SERVICE BULLETIN REVISION TRANSMITTAL SHEET

Service Bulletin No. 605-32-010

Revision No. 01 Dated Nov 04/2025

MODIFICATION – NOSEWHEEL STEERING – REPLACEMENT OF POTENTIOMETER UNIVERSAL COUPLING (T16-6) SETSCREWS

Replacement of Universal Coupling (T16-6) Setscrews
Figure 1

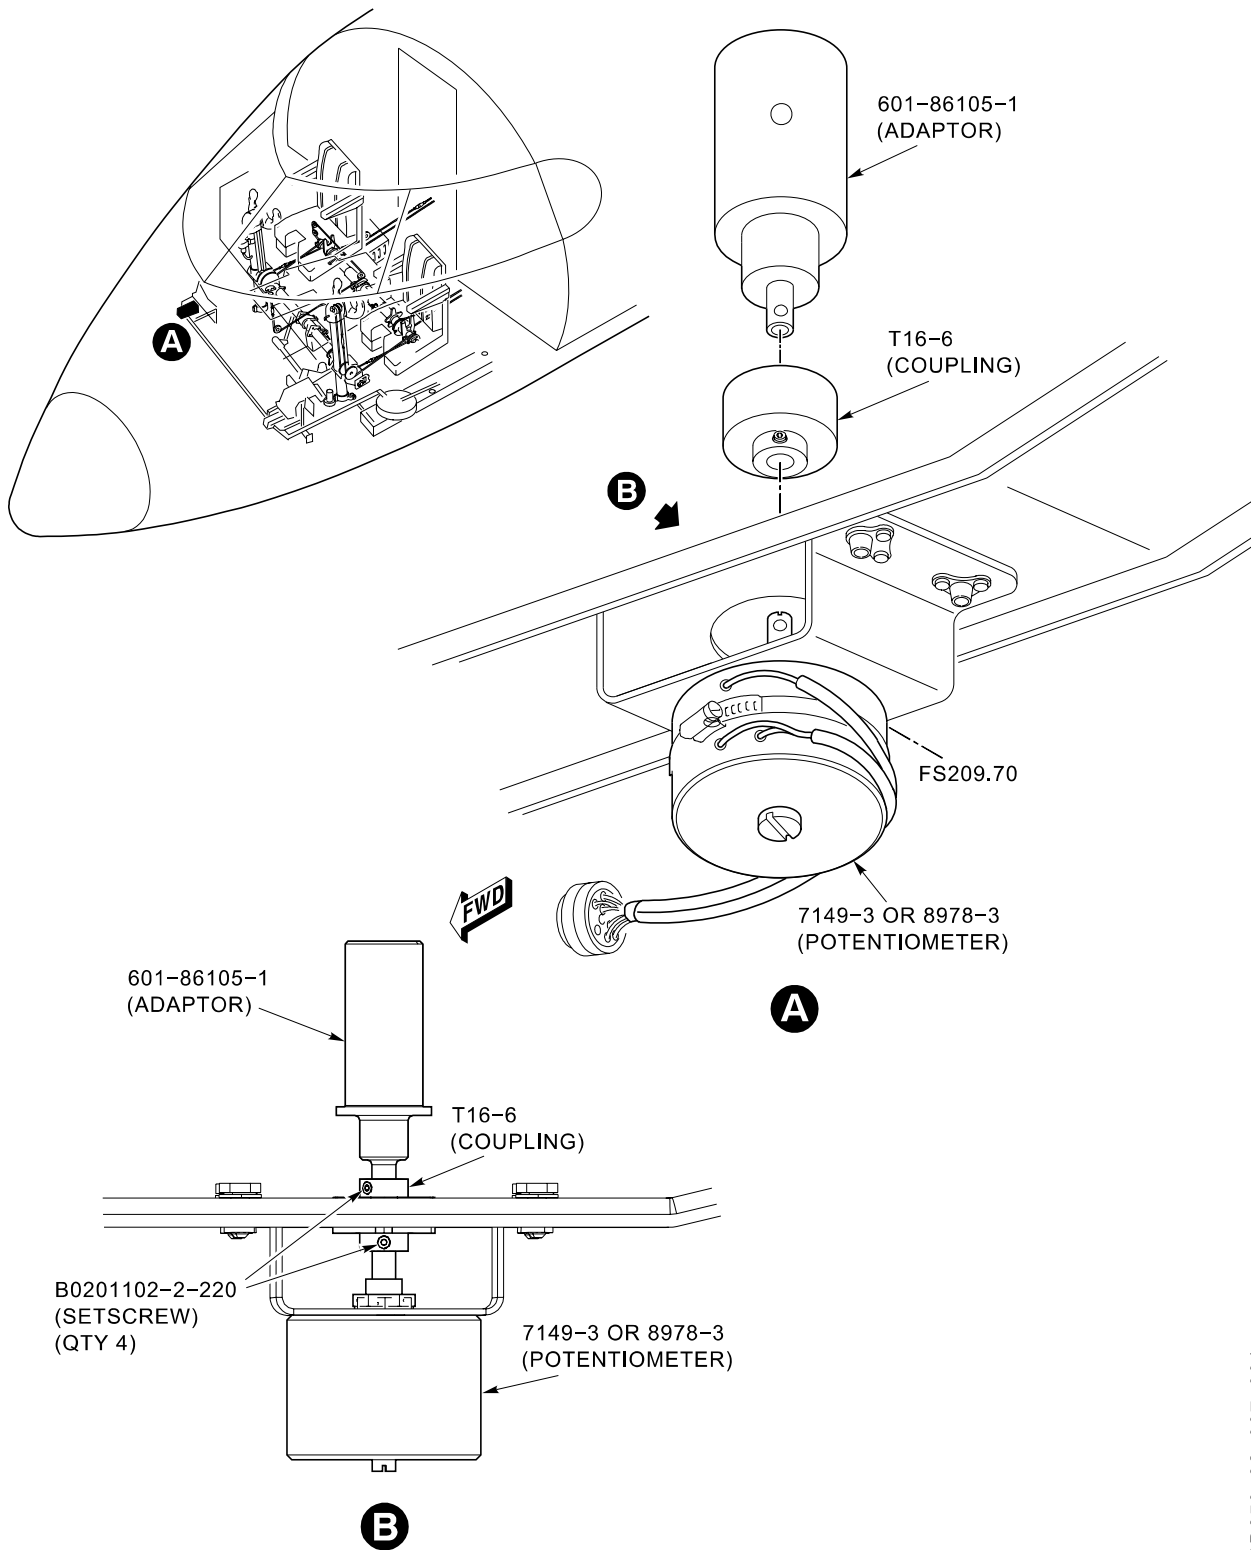
- (1) Get access to potentiometer universal coupling, Part No. T16-6 on rudder feel unit assembly.
- (2) Replace the rudder potentiometer universal coupling as follows:

- (a) Remove the potentiometer and coupling per AMM 32-51-04-000-801 in accordance with AMM Rev 72 and subs, per the applicable procedure (Pre SB 605-32-010).

- (b) Install the new coupling and potentiometer per AMM 32-51-04-400-801 in accordance with AMM Rev 72 and subs, including the task instructions related to Post SB 605-32-010 (using new coupler, new type self-locking setscrews, anaerobic retaining compound and specified torque).

NEW PART NO.	QTY	ITEM	USED PART NO.	INSTRUCTIONS - DISPOSITION
B0201102-2-220	8	Self-locking Setscrew	MS18063-2	Discard

- NOTES:
1. In case of discrepancy between this list and the Service Bulletin Kit Parts List contained in the respective kit, then the later list prevails.
 2. The actual quantity for some of the hardware contained in the kit can be greater than the amount shown in the table as these items are supplied in prepackaged quantities.
 3. The self-locking setscrew can be identified by its yellow locking patch.
